Development Review Comments

May 27, 2025
Project No. PJT2025-0023, WAV2025-00015 & WAV2025-00016

1st Submission Review Comments

Momentum at Rockville Station – 41 Maryland Avenue

PRELIMINARY FOREST **CONSERVATION PLAN**

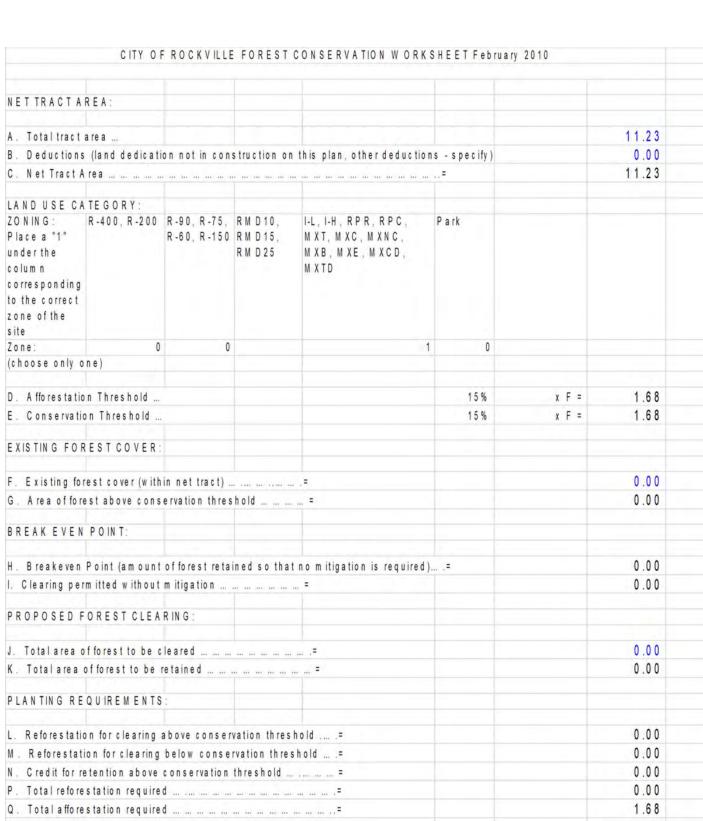
PFCP comments are provided separately with the individual PFCP application submittal
